Crystal River Nuclear Plant
Docket No. 50-302
Operating License No. DPR-72

Subject: Crystal River Unit 3 – Response to Request for Additional Information Regarding Relief Request #08-002-RR, Revision 0, Dissimilar Metal Weld Overlay Repair During the Fourth 10-Year Inservice Inspection Interval (TAC NO. ME0023)

Response to Request for Additional Information

Figure 1

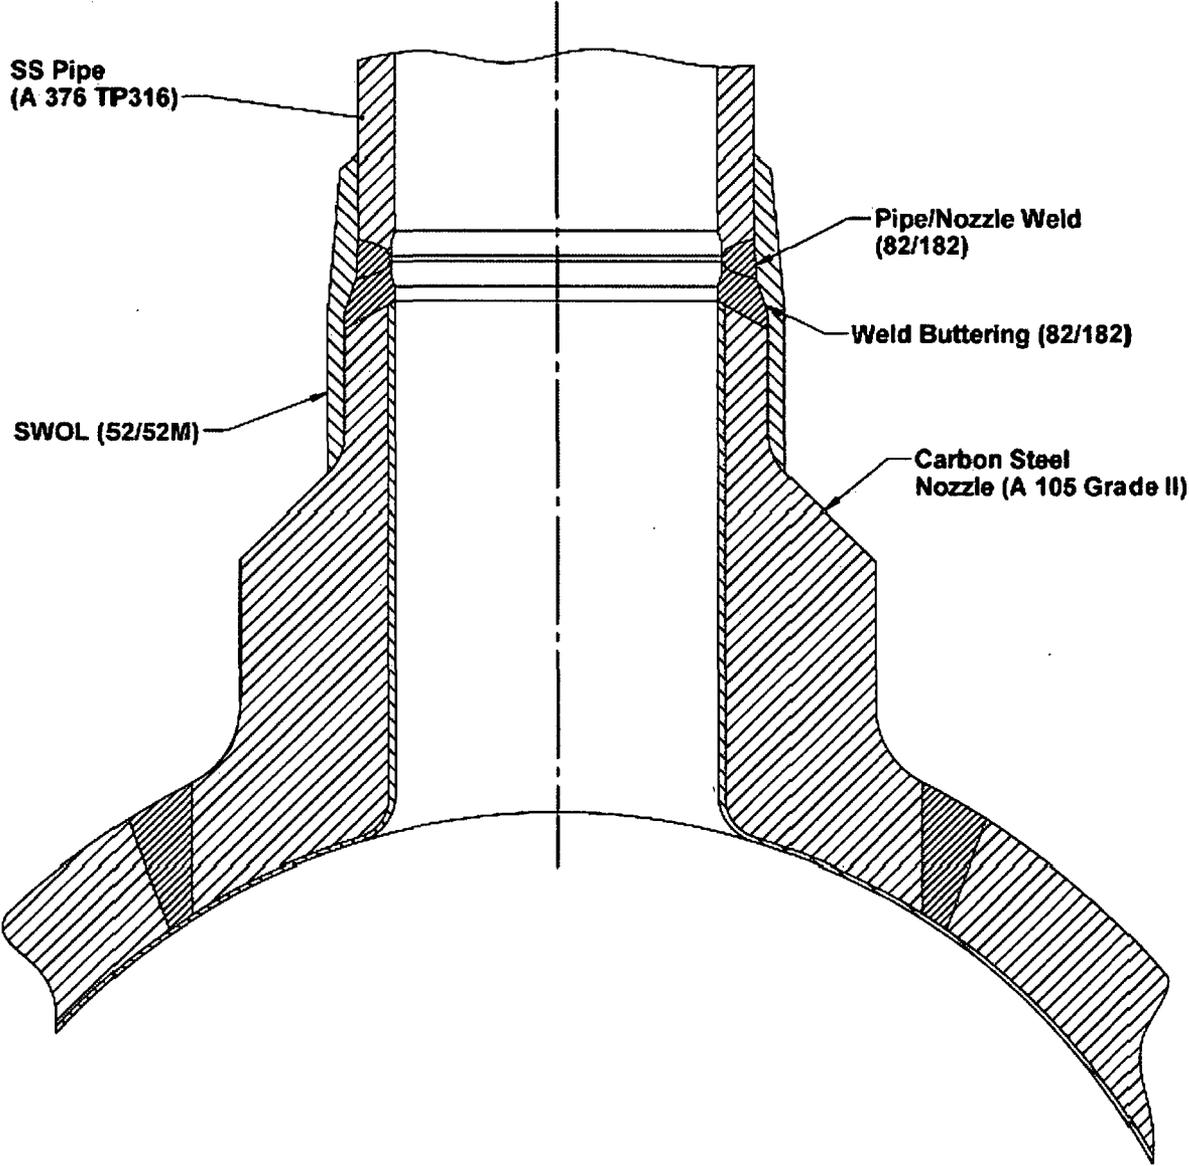
- 1) In Attachment 1, paragraph 5.1, SWOL [Structural Weld Overlay] Design, the licensee states that there may be small remnants of austenitic weld overlay material remaining on the nozzle/dissimilar metal weld (DMW)/pipe surface that may not be removed prior to the new SWOL.
 - a. Please provide detailed information on the prior weld overlay and the reason for its removal, along with its composition particularly its sulfur content, its physical area and thickness, and the type and location of its substrate material (on which the overlay is welded).

The original SWOL, using a gas tungsten-arc welding (GATW) machine, with ERNiCrFe-7 (Alloy 52M) with a sulfur content of 0.001 percent, covered the original DMW and extended from the DMW onto the ferritic steel nozzle to its shoulder and onto the austenitic stainless steel piping as depicted in Figure 1.

The original DMW consists primarily of Alloy 182 (ENiCrFe-3), the ferritic carbon steel nozzle is ASTM A 105 Grade II and the attached austenitic stainless steel pipe is ASTM A 376 TP316 as depicted in Figure 1.

Since the attached stainless steel pipe had a relatively high sulfur content, a single layer barrier weld using ER309L, with a sulfur content of 0.01 percent, was welded onto the stainless steel pipe near the DMW using the machine GTAW process prior to welding the overlay. A single layer of Alloy 82, with a sulfur content of 0.003 percent, was then welded over the DMW to a stainless steel pipe interface and "tied in" with the ER309L, also using the machine GTAW process. The barrier weld covered the entire portion of the stainless steel pipe where the weld overlay was to be deposited, as depicted in Figure 1, in accordance with Weld Procedure Specification (WPS) 55-WP1/8/43/F43OLTBSCa3-003 (see Attachment 2 to this Enclosure).

The approximate surface areas to be covered by the weld overlay were 160 square inches over the ferritic carbon steel nozzle, 90 square inches over the DMW (Alloy 182 buttering and pipe to buttering weld) and 110 square inches over the stainless steel pipe. The final overlay thickness was approximately 5/8 inch over the ferritic carbon steel nozzle and the outer portion of the overlay over the stainless steel pipe, with slightly larger thicknesses in the area near and on portions of the DMW. The general profile is shown in Figure 1.
